Access Compliance Report

Public Rights-of-Way

(Pedestrian Signals)

Intersection ID: N/A	Main Street:	Cross Street: N/A	Location: N/A
ADA ID: 0CA2E1EDC6FE	Signal Type: One Push Button-APS	Overall Compliance: No	Severity Score: BTN 1: N/A BTN 2: N/A No BTN: N/A
Codes/Mitigation Info/Possible Solution		Field Measurements/Component Compliance

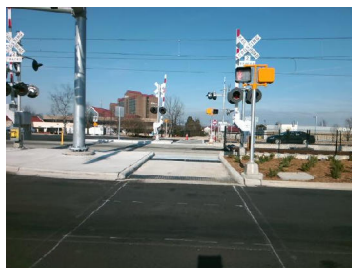
PROW/ADA: TMUTCD 4e.08, R404.2, R404.7.3, R404.7.2, R209.1, MUTCD 4e.10

N/A	B 1 Clear Xing Direction?	Yes	N/A	B 2 Clear Xing Direction?	N/A
	B 1 Crossing Direction	To SE		B 2 Crossing Direction	N/A
Yes	B 1 DistanceTo XWalk (in)	6.0	N/A	B 2 DistanceTo XWalk (in)	N/A
No	B 1 DistanceTo Curb (in)	5.0	N/A	B 2 DistanceTo Curb (in)	N/A
Yes	B 1 Diameter (in)	2.0	N/A	B 2 Diameter (in)	N/A

Possible Solutions: Replace Signal Push Button With APS Button on New Post. Remove & Relocate Sign.
